**6711531  
FRC-EAST, CRANE  
REPLACEMENT AND  
MODERNIZATION**

**MCAS Cherry Point, NC  
AMENDMENT #0001**

This amendment is being issued to provide responses to the attached RFIs and updated drawing/spec sections as outlined in the continuation sheet attached.

DWG NO.	TITLE
PE-21753 4 of 6 Rev 1	WORK PLAN & NOTES – WORK SITES 3 & 4 – BUILDING 133, revised 3/22/19
PE-21753 5 of 6 Rev 1	PICTURES – WORK SITES 3 & 4 – BUILDING 133, revised 3/22/19
PE-21753 6 of 6 Rev 1	WORK PLAN, WORK NOTES AND PICTURES – WORK SITES 5 & 6 – BUILDING 137, revised 3/22/19

**WORK PLAN - WORK SITE 5 - BUILDING 137**  
SCALE: 1/8" = 1'-0"

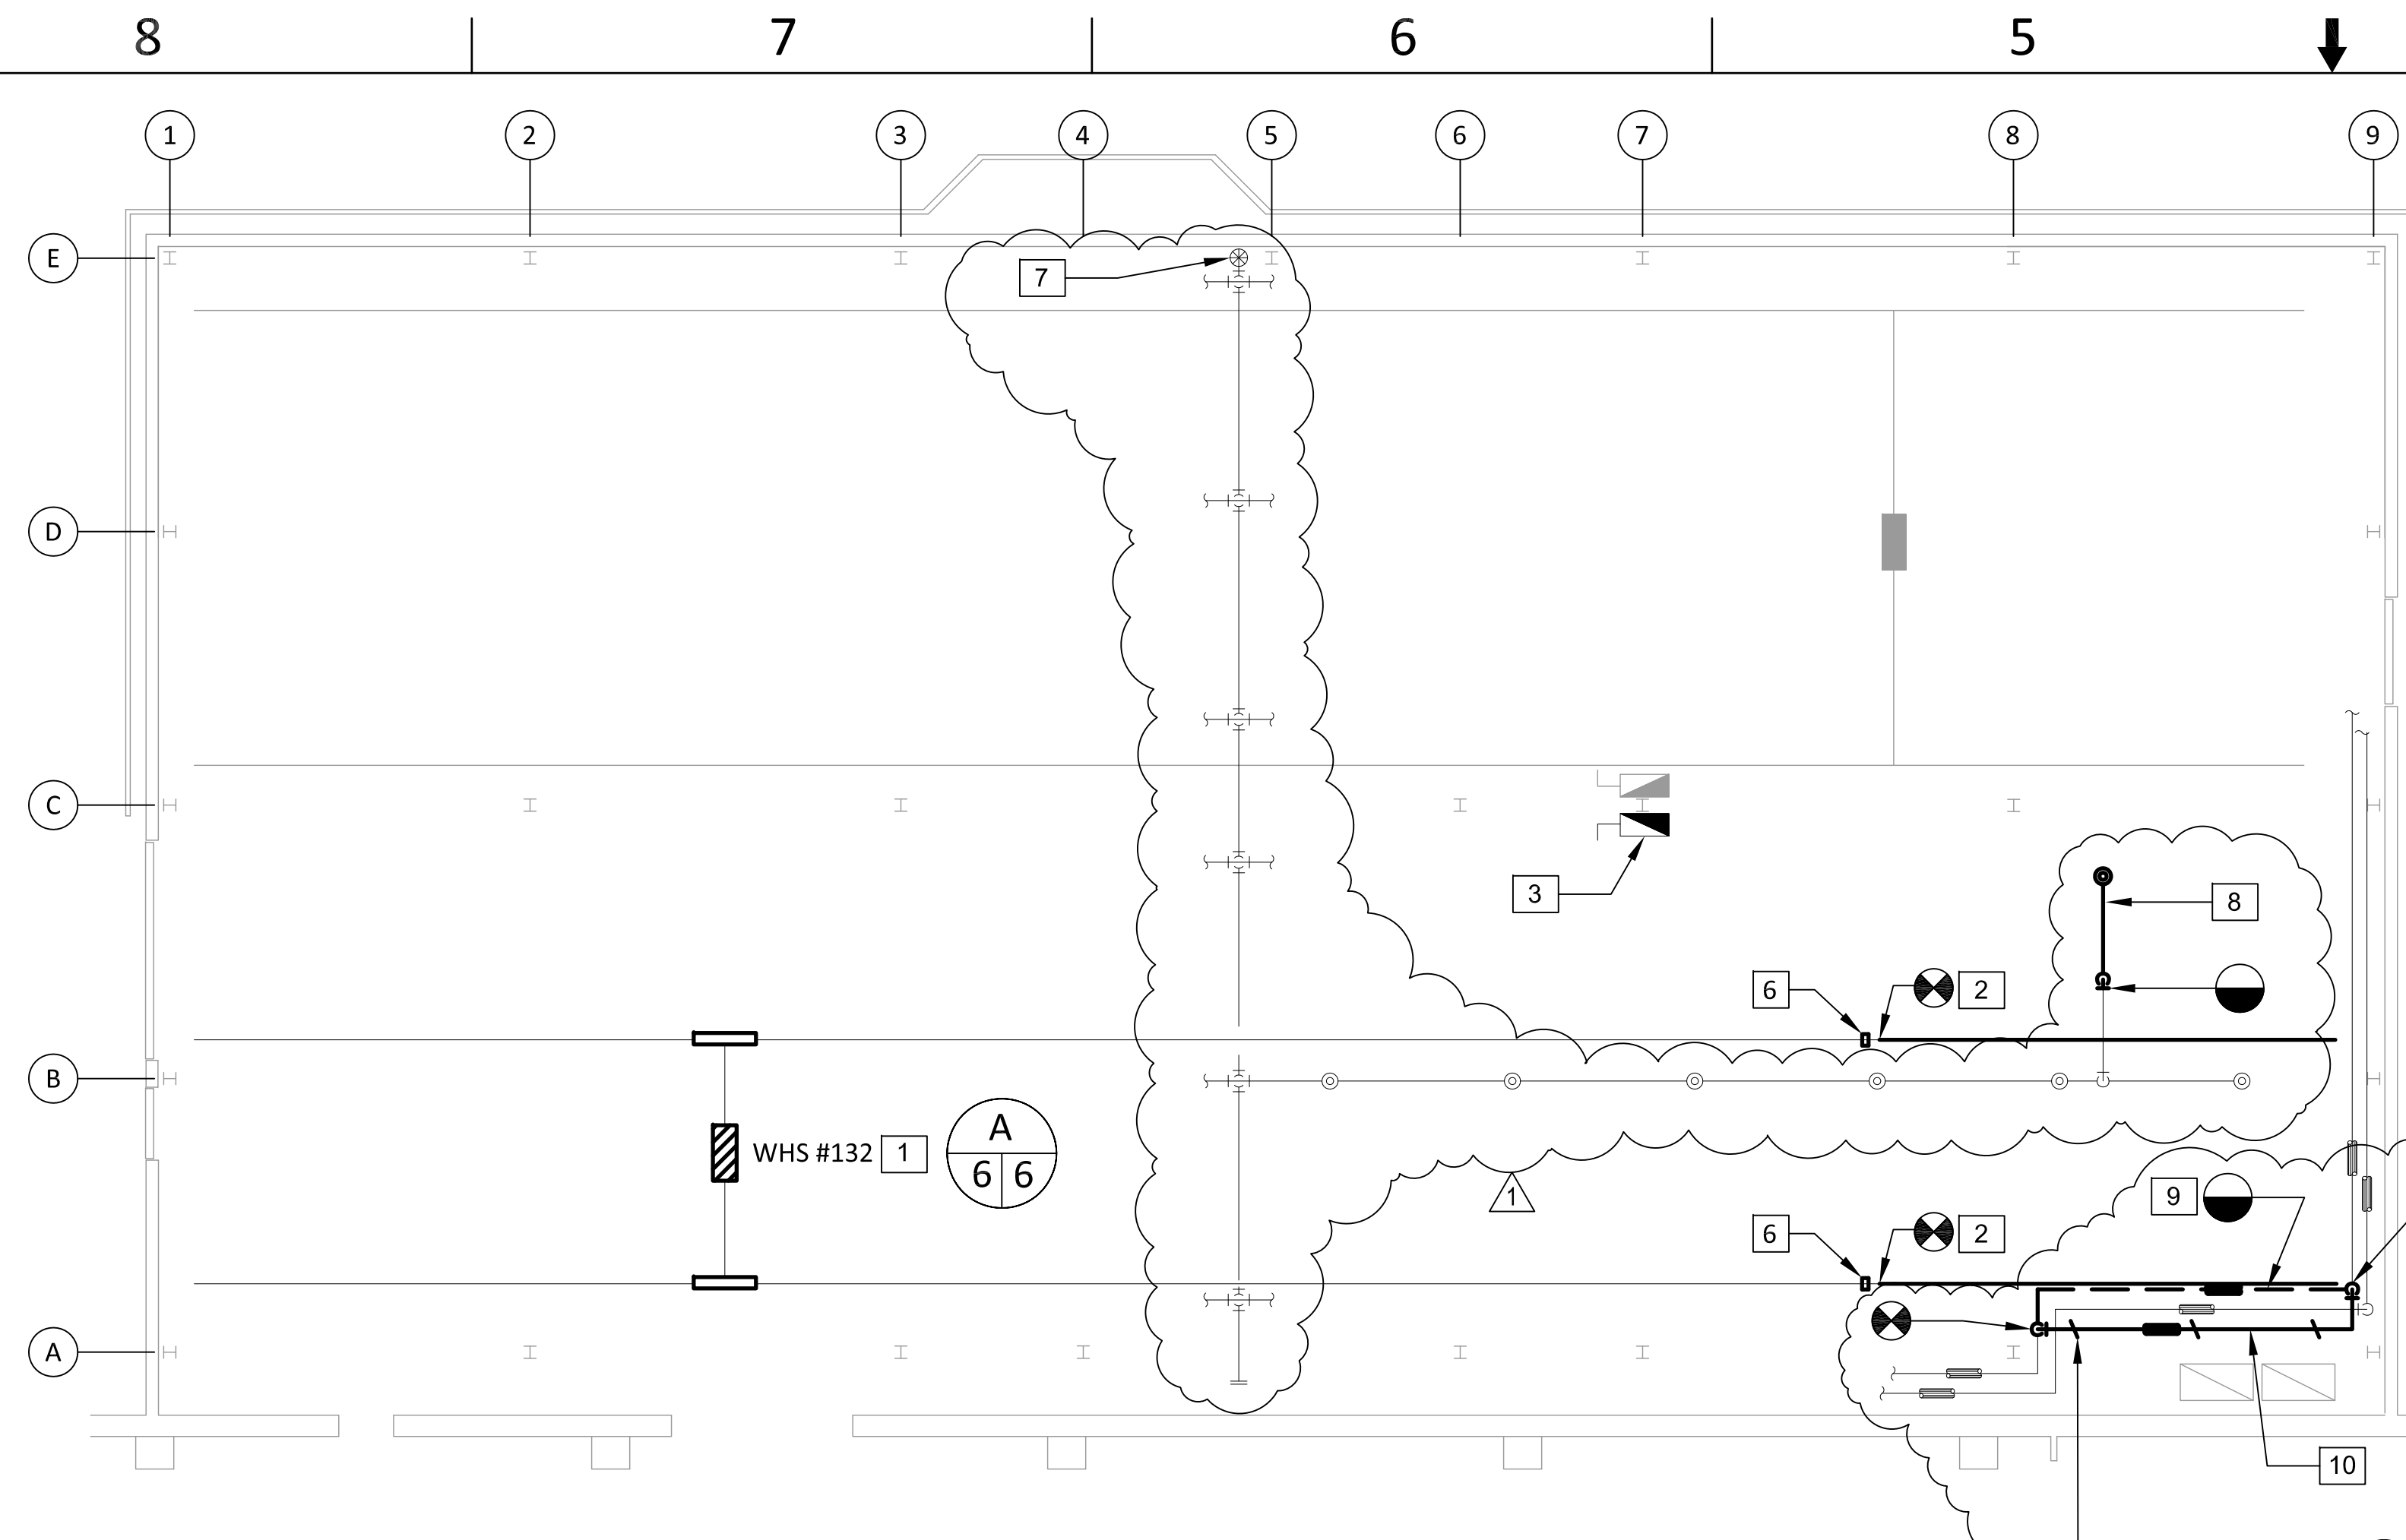
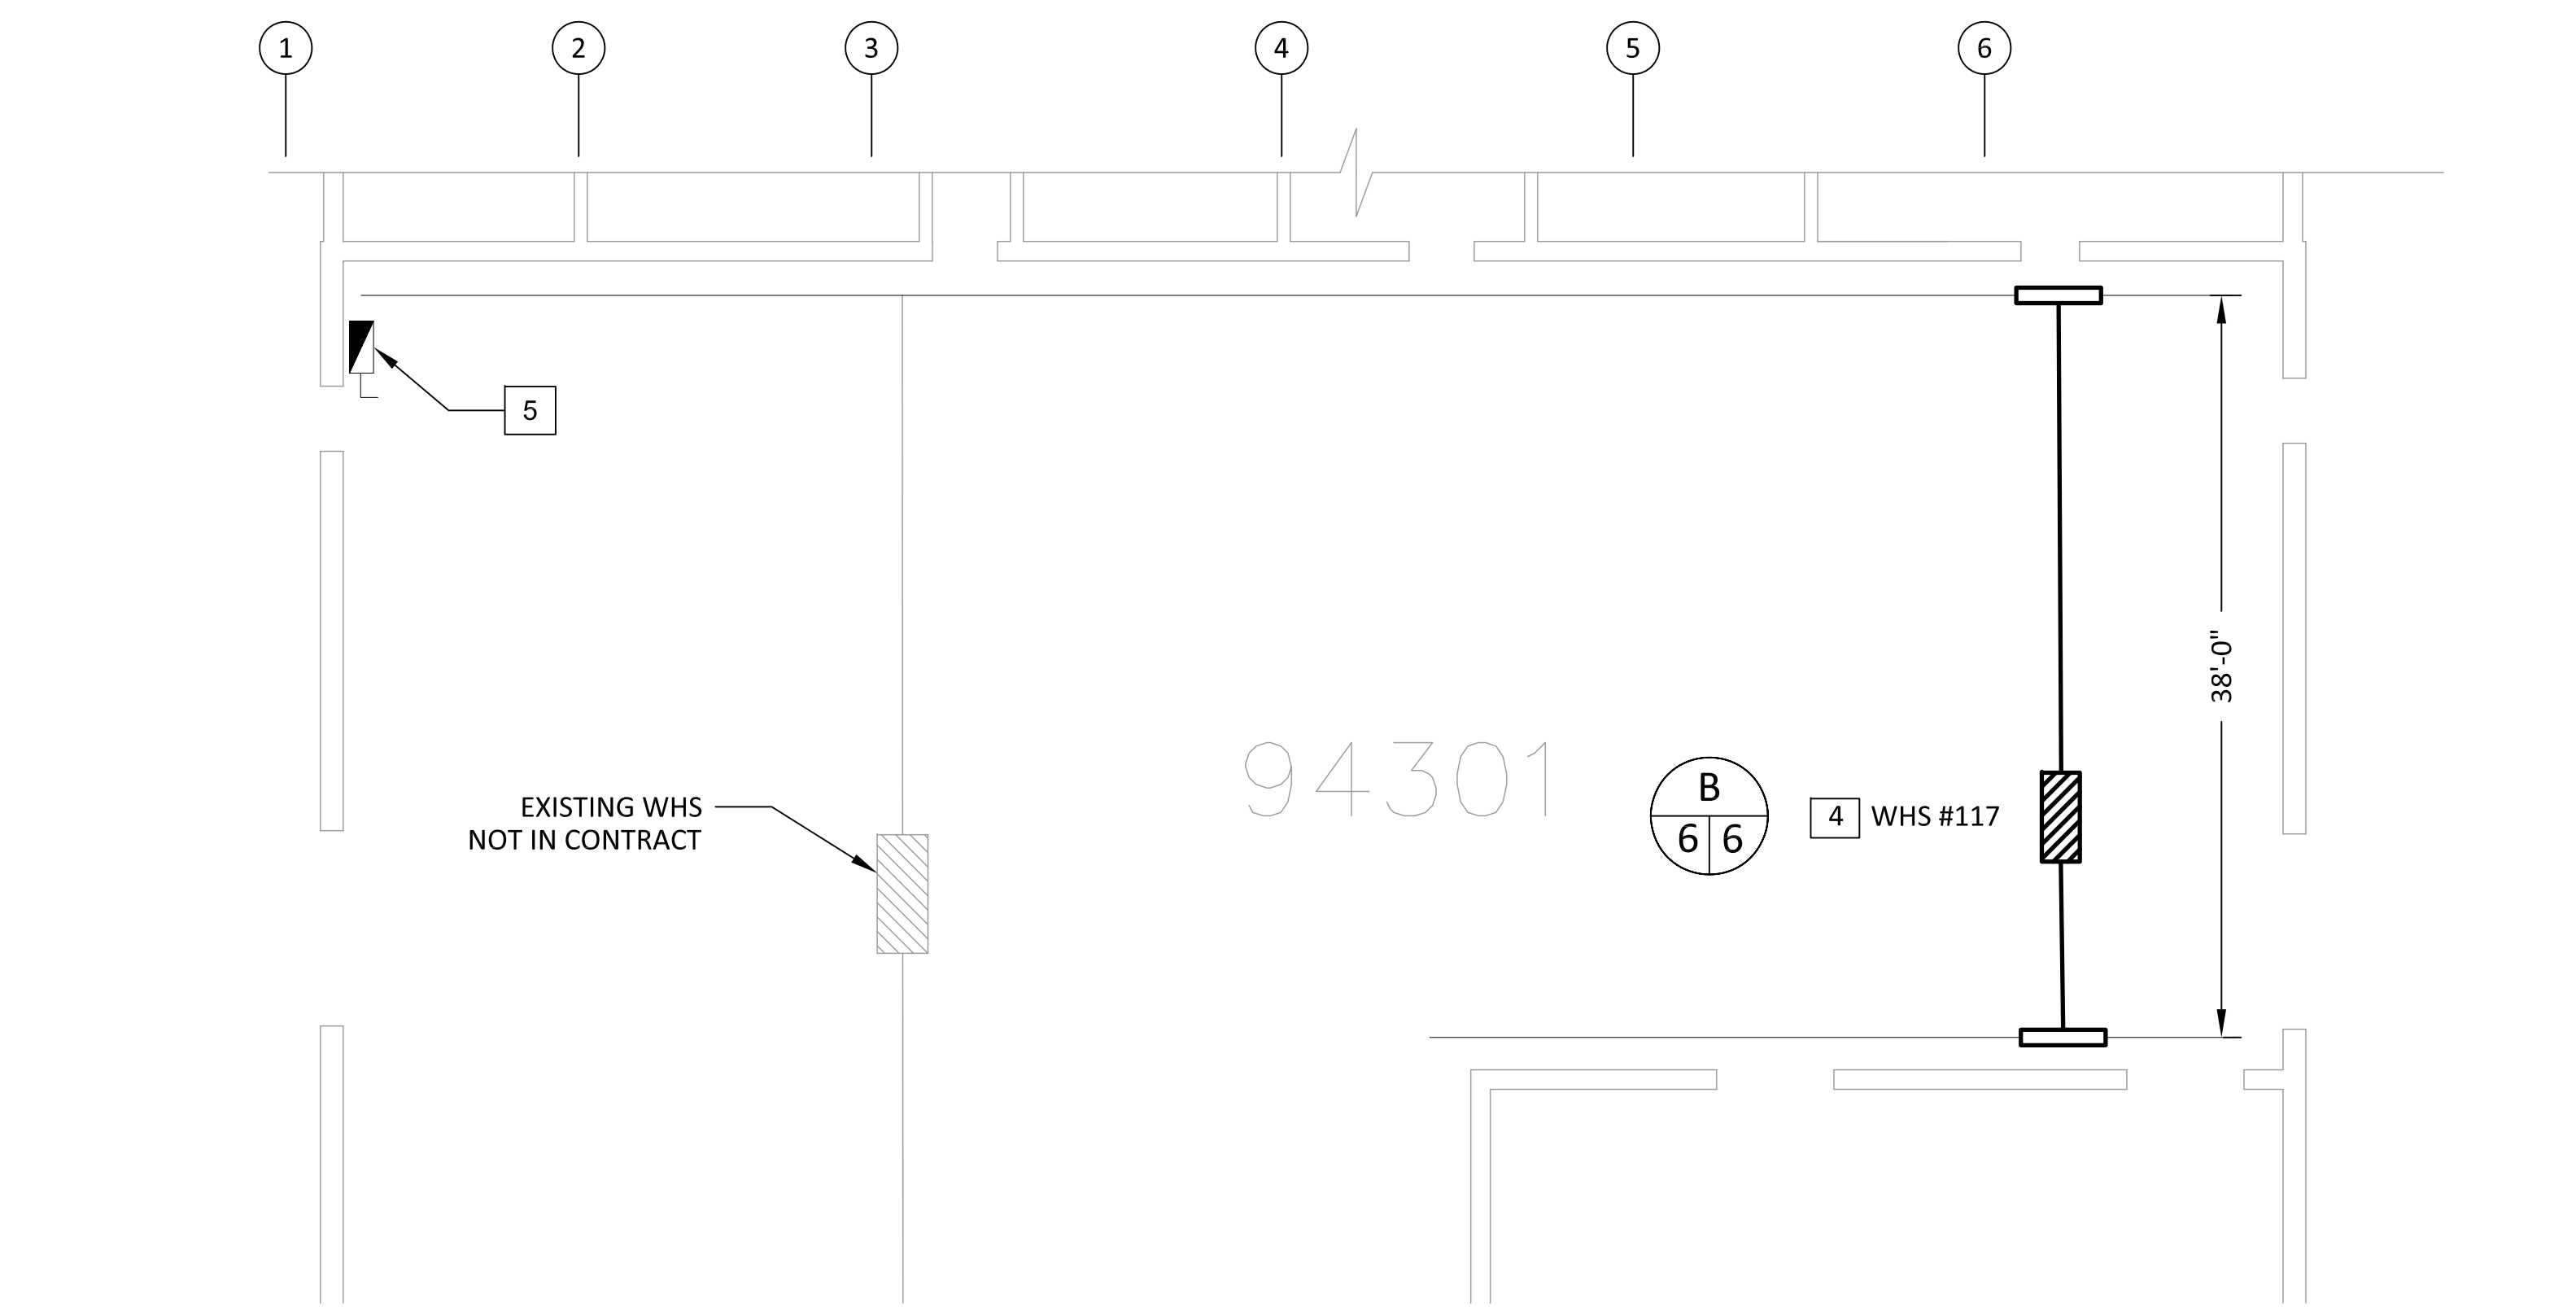
2. In building 137, Crane WHS #132 calls for it to be extended by 25', but there are steam pipes obstructing the path of this that will have to be relocated before this can be installed. As this is not part of the Scope of Work, how would you like us to address this?

ZONE	REV	DESCRIPTION	DATE	APPR.
		WHS #132 SCOPE OF WORK REVISED	3/22/19

*Response: Please refer to revised specification section 01 90 00, dated 3-29-2019. Please also refer to revised drawings PE-21753 4 of 6 Rev 1, PE-21753 5 of 6 Rev 1, and PE-21753 6 of 6 Rev 1. Submit Proposals in accordance with RFP, Specifications, Drawings, and all Amendments.*

- 9 EXISTING 2 1/2"Ø LOW PRESSURE STEAM PIPE @ 15'-0" AFF (APPROX.) TO BE REROUTED TO ALLOW FOR RUNWAY RAILS EXTENSION. A MINIMUM CLEARANCE OF 12" MUST BE PROVIDED BETWEEN THE WHS AND ANY BUILDING COMPONENT.

- 10 NEW RE-ROUTED 2 1/2"Ø LOW PRESSURE STEAM PIPE. PIPE AND FITTINGS MUST BE SCHEDULE 40 SEAMLESS OR ELECTRIC RESISTANCE WELDED BLACK CARBON STEEL CONFORMING TO ASTM A53/A53M. PIPE MUST BE INSULATED USING 3" THICK CELLULAR GLASS INSULATION TYPE II, CONFORMING TO ASTM C552. SUPPLY THE INSULATION WITH MANUFACTURER RECOMMENDED FACTORY APPLIED JACKET.
